STAFF REPORT

SUBJECT: FP-2022-0015
Vertex Subdivision No 1 Final Plat

Final plat consisting of 37 buildable lots and 9 common lots on 12.1 acres of land in the R-8 zoning district, by Brighton Development Inc.

D. Proposed Landscape Plan (date: 5/10/2022)

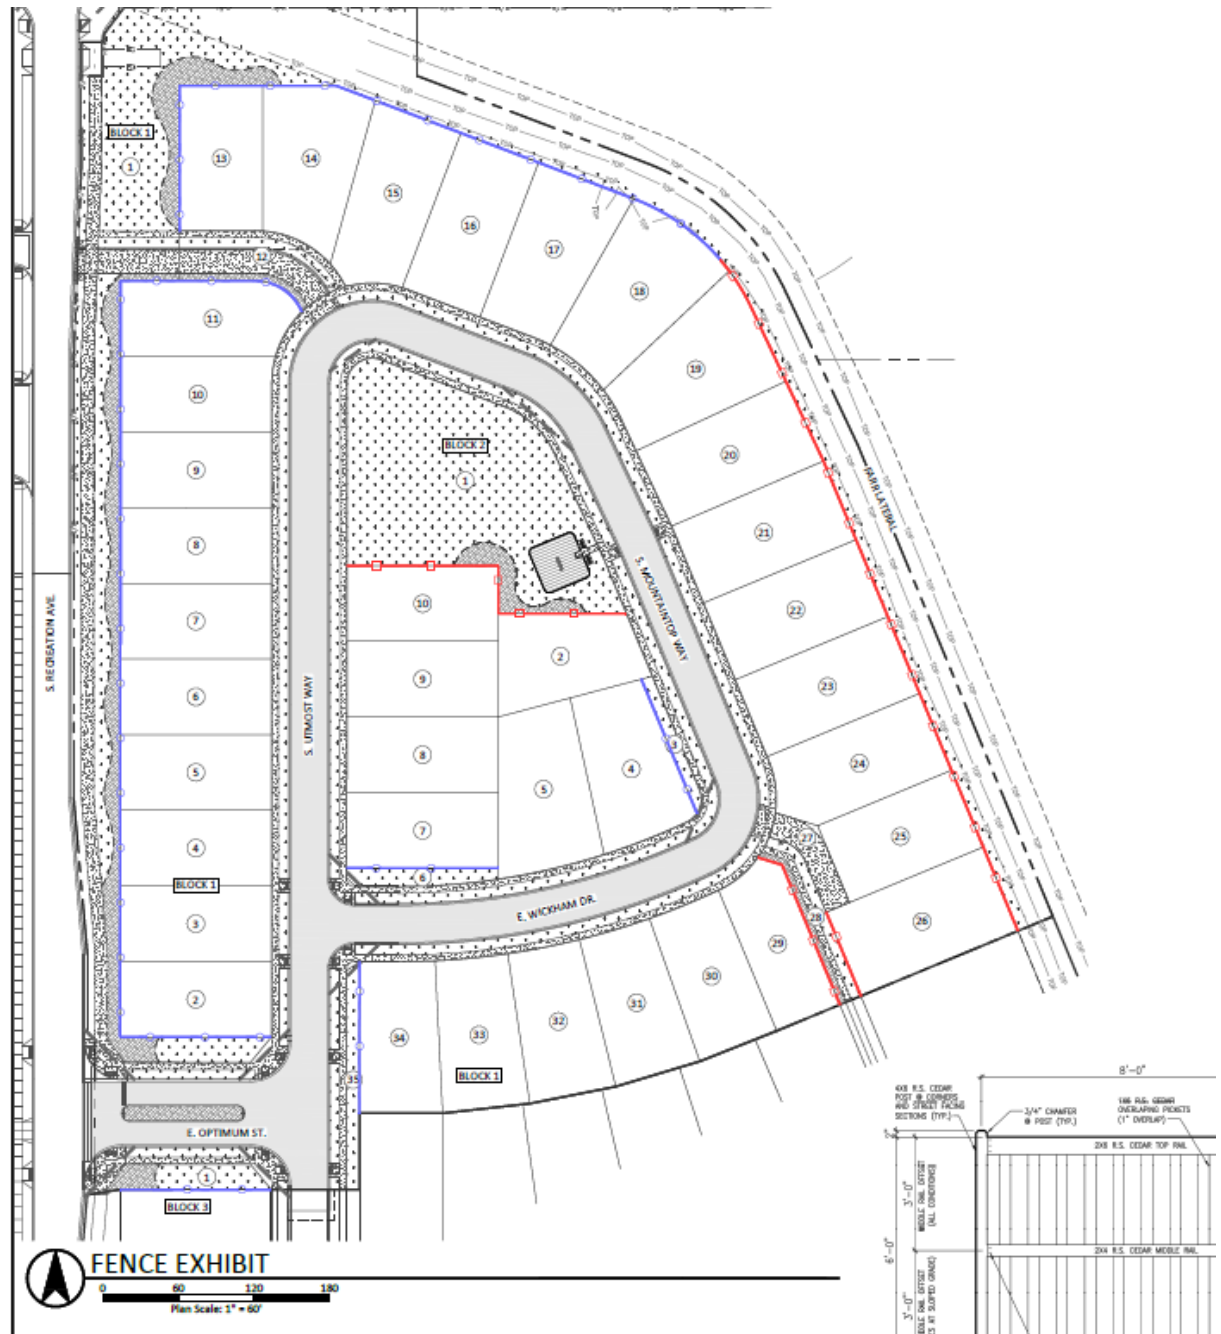
6. The landscape plan prepared by KM Engineering, dated 05/10/2022, is approved as submitted with the revision that the micropath in Lot 12, Block 1 be landscaped as required per UDC 11-3B-12.
